COUNCIL ASSESSMENT REPORT

SYDNEY EASTERN CITY PLANNING PANEL

PANEL REFERENCE & DA NUMBER	PPSSEC-241 – DA-2022/329
PROPOSAL	Integrated Development – Demolition of existing structures and construction of four (4) x eight (8) storeys residential apartment buildings comprising of 196 apartments including 98 affordable housing units over three (3) levels of basement parking
ADDRESS	Lot 13 in DP 663383, Lot 1 in DP 923896 and Lots 14 to 24 in Section 1 in DP 4059 Nos. 15 – 37 Innesdale Road Wolli Creek
APPLICANT	The Trustee for Innesdale Property Holdings Trust ²
OWNER	Ms Mona Elizabeth Goldsmith Innesdale Holdings Pty Ltd Ms Amal Kemp Mr Emil Peter Moussa Mr Phillip Moussa
DA LODGEMENT DATE	10/11/2022
APPLICATION TYPE	Integrated Development Application
REGIONALLY SIGNIFICANT CRITERIA	Section 2.19(1) and Clause 2 of Schedule 6 of <i>State Environmental Planning Policy (Planning Systems) 2021</i> declares the proposal regionally significant development as: Development that has a capital investment value of more than \$30 million.

Figure 5 – South elevation plan (residential building) showing the height breach at the lift overrun

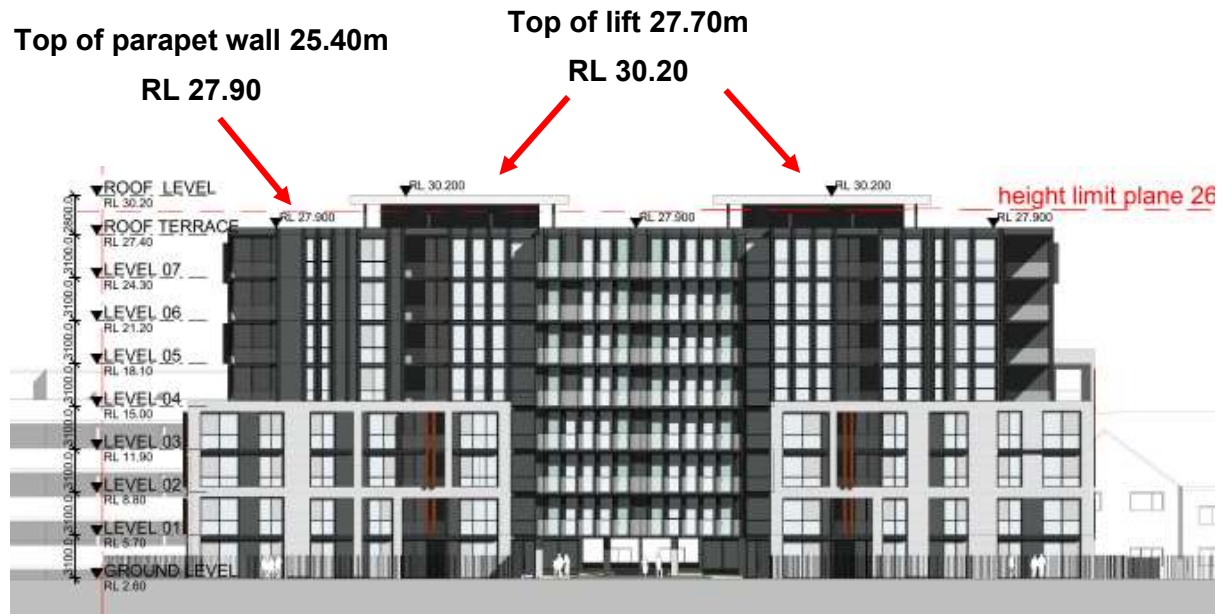
The height of each of the proposed buildings is 27.7m (RL 30.2m to the top of the lift overrun and adjacent awning on the roof top terrace level) which exceeds the maximum 26.5m height permitted in Clause 4.3 (Height of buildings) of RLEP 2011. This represents a variation of 1.2m or 4.5% from the maximum height control. The variation to the height control relates to the lift overrun and providing access to the roof terrace, including stair access to this space, as shown in Figure 4 as detailed below:

The subject site is constrained as a result of a flooding affectation. Accordingly, the ground level of the development is required to be raised in order to provide minimum habitable floor levels which will be above the flood level for the site. The flooding affectation is directly correlated to the additional height proposed in this instance. It is noted that in the event that the site was not subject to a flooding constraint the proposed development to the roof level would comply with the height limit for the site.

The proposal is satisfactory with regards to the setback requirements in the ADG and Council's DCP which set the envelope controls for the site, and which ensure that adequate landscape planting is provided within each setback. Based on the statements above, the arguments put forward in the applicant's written request confirm the proposal achieves the objectives of the standard notwithstanding the non-compliance. Accordingly, compliance with the development standard is unreasonable or unnecessary in the circumstances of the case.
